Subject: **Request for Modification to Individual Permit Application and 401 Water Quality Certification** for the US 64 Relocation from US 19/74/129 in Murphy to east of NC 141 in Peachtree, Cherokee County. State Project No. 8.1910203. Federal Aid Project FR-14-1(1). TIP No. R-0977A. NCDOT Division 14. Debit \$570.00 from WBS Element 34357.1.1

The purpose of this letter is to request a modification of the existing Section 404 IP and Section 401 WQC. The activities and impacts occurring at each site are described, and revised project impacts are listed in Tables 1 and 2. Permit drawings and a Rapanos package are attached to this permit modification application. The EEP Acceptance Letter will be forwarded upon receipt by NCDOT.

PROJECT 8.1910203 (R-977A)
PROPOSED US 64 RELOCATION FROM
EXISTING US 19-74-129 IN MURPHY
TO EAST OF NC 141 IN PEACHTREE

MOD. - MARCH 2008 SITE 19

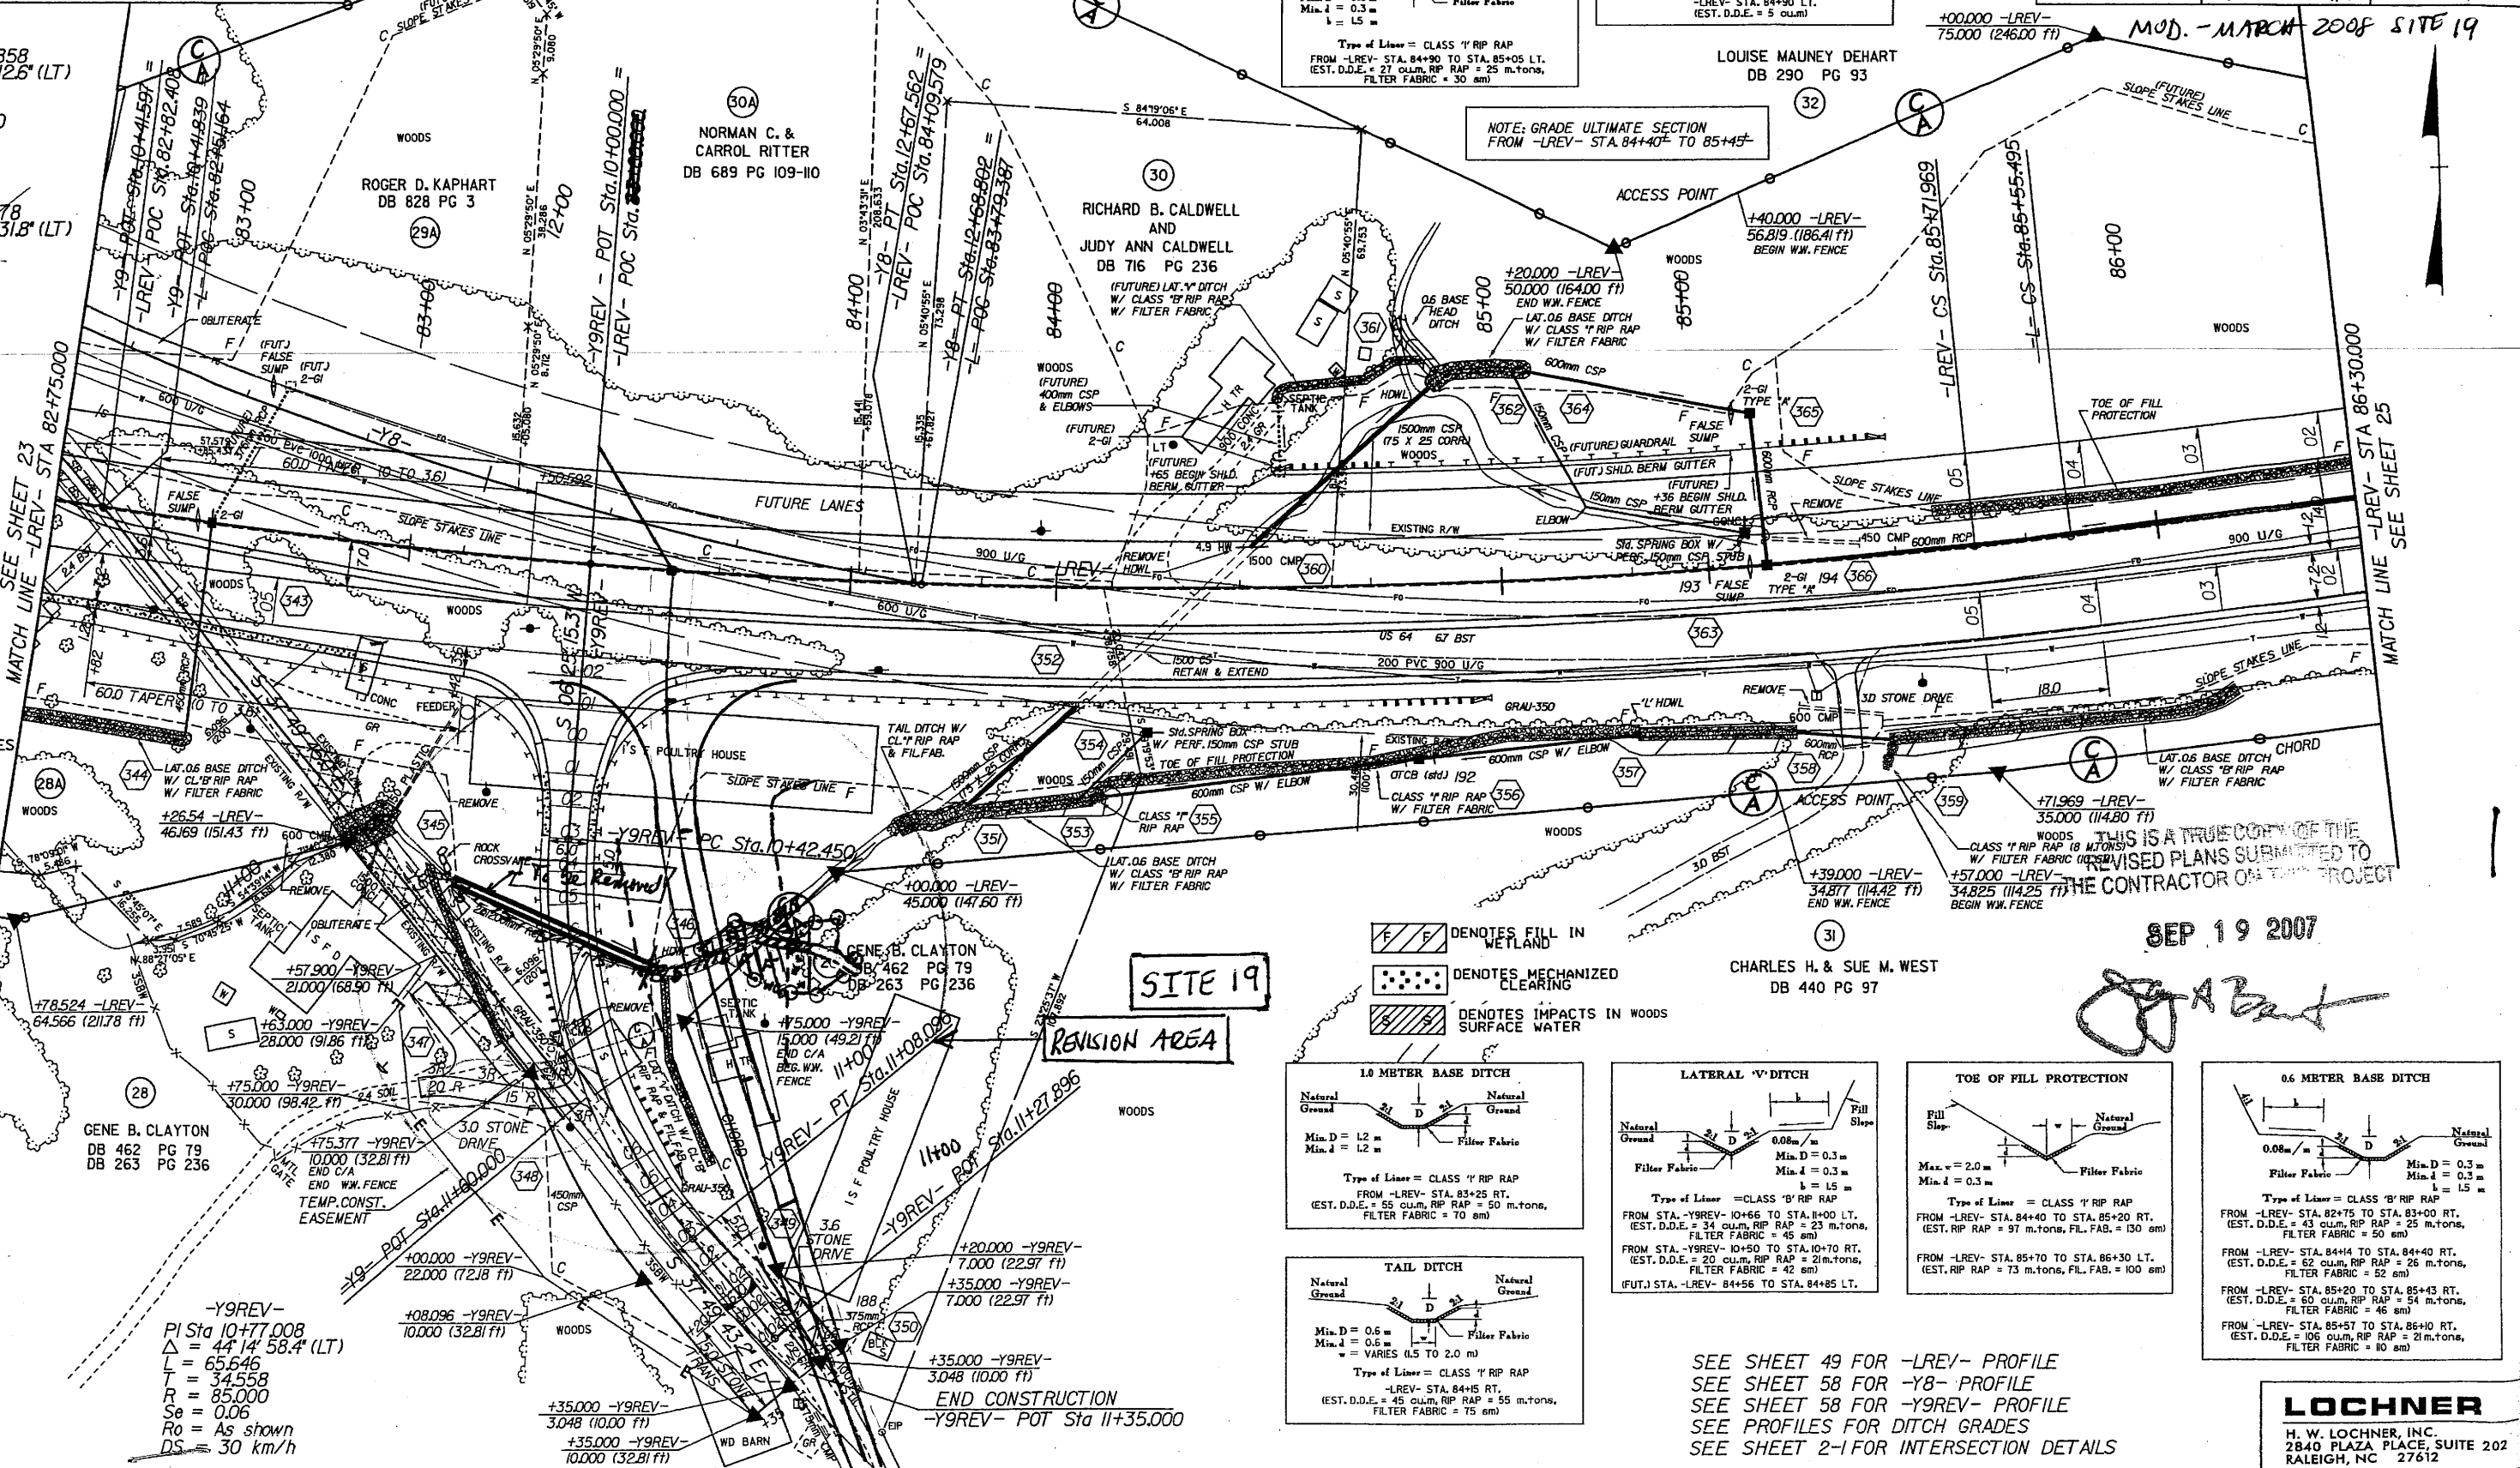
Modification activity at Station 10+60 -YREV- (see Mod-April 2008 Site 19 Sheet)

Due to driveway conflicts associated with the grade of the proposed Y9, the adjacent property owner requested that NCDOT redesign the Y-line to better accommodate access to his property. NCDOT proposes to remove the partially constructed Y9, which includes removal of a 115-foot section of pipe from an unnamed tributary (UT) to McCombs Branch and restoring the stream. The relocation of Y9 will require the piping of a 92-foot long adjacent section of UT to McCombs Branch, and the piping of 28 feet of a stream that confluences with UT to McCombs Branch. In addition, there will be 0.02 acre of impact due to fill and 0.01 acre of impact from mechanical clearing of an adjacent wetland. There will be 0.02 acre of new temporary impacts due to dewatering in order to remove the existing pipe and reinstall on new location.

Existing Permitted Impact: 151 linear feet of stream impact (a 115-foot pipe segment and a 36-foot long riprap segment located upstream)

Revised Impact: 271 linear feet of stream impact (**120 LF of new stream impact**), and **0.03 acre of new wetland impact**).

New Temporary Impact: **0.02 acre**

Mitigation: 5 LF of net stream mitigation and 0.03 acre of wetland mitigation needed.

The 5 LF of net mitigation results from the difference between the 115 linear feet of stream to be restored with the pipe removal and the 120 linear feet of new stream impact.

Site 19: Original proposed 2 @ 1200 RCP has been installed but will be removed (115') and relocated (92'); Additional impact of 120 feet includes main stream and trib (92' + 28').
